CITY OF ALBUQUERQUE

**Re: SEVEN CLOVER DISPENSARY
3641 12TH NW
ALBUQUERQUE, 87122
Traffic Circulation Layout
Engineer's/Architect's Stamp 5/1/2024 (G14D062)**

Based upon the information provided in your submittal received 5/6/2024, the above referenced plan cannot be approved for Building Permit until the following comments are addressed:

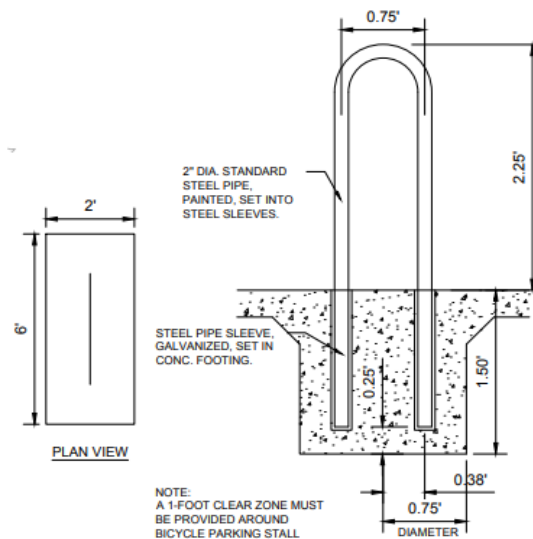
1. Show exiting, entrances, sidewalk, ramp and curb and gutter on the site plan.
2. The bike rack is too small. The rack shall be a minimum 30 inches tall and 18 inches wide.

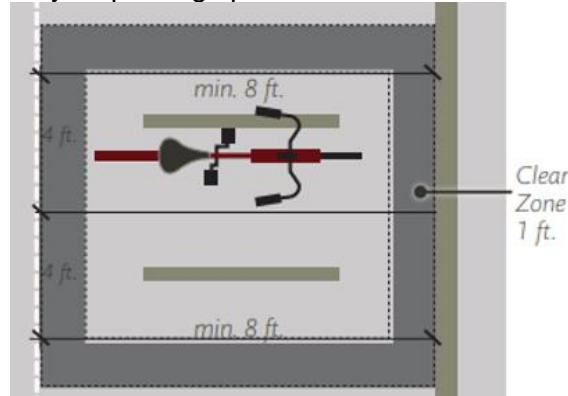
3. Bicycle parking spaces shall be at least 6 feet long and 2 feet wide.

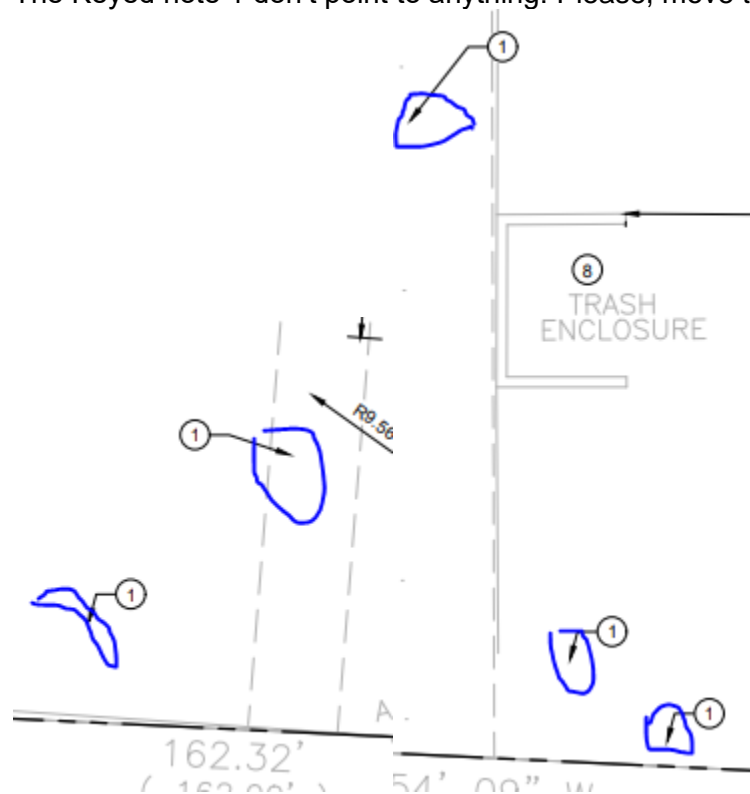
4. Show the clear sight triangle and add the following note to the plan: "Landscaping and signage will not interfere with clear sight requirements. Therefore, signs, walls, trees, and shrubbery between 3 and 8 feet tall (as measured from the gutter pan) will not be acceptable in the clear sight triangle."
5. Replace the 6" in the Keyed Note 19 by 8" curb, Curbs on arterial streets are usually 8" tall.
6. Provide Fire and Solid Waste Departments Approvals for the new layout
7. The Keyed note 1 don't point to anything. Please, move them to point to correct objects.

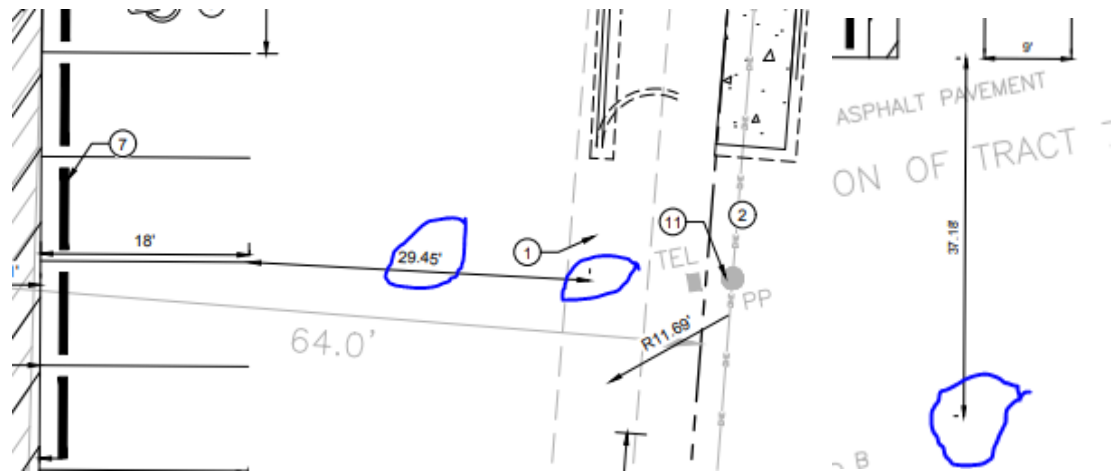
8. The 29.45' dimension for the east drive aisle and a the 37.18' dimension on the south side of the building do not point to anything on the east side.

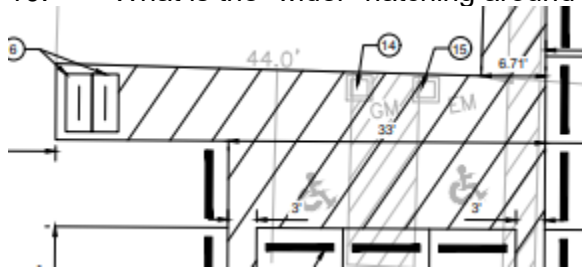
10. What is the "wider" hatching around the building supposed to represent?

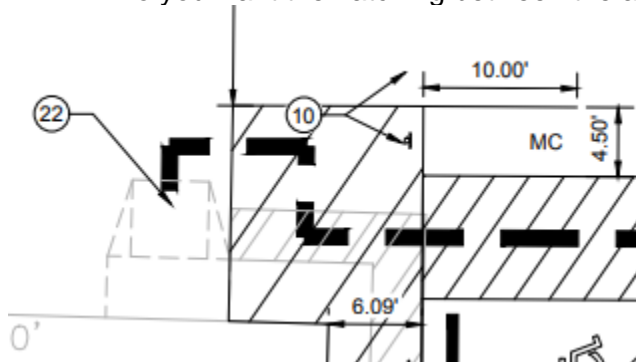
11. Do you want the hatching between the accessible aisle and the door to be painted?

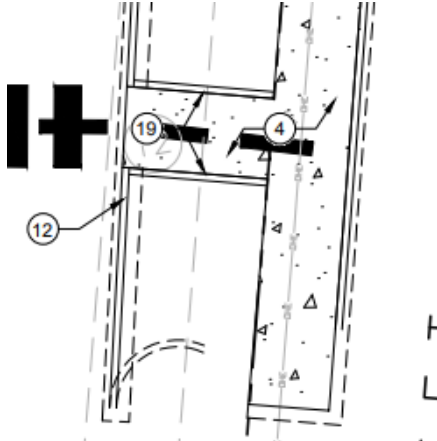
12. Provide the width of the sidewalk from 12th st onto the site.

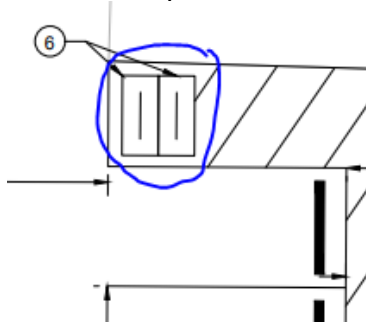
13. Will the bicycle racks interfere with sidewalk usage for customers that park west of the accessible spaces south of the building.
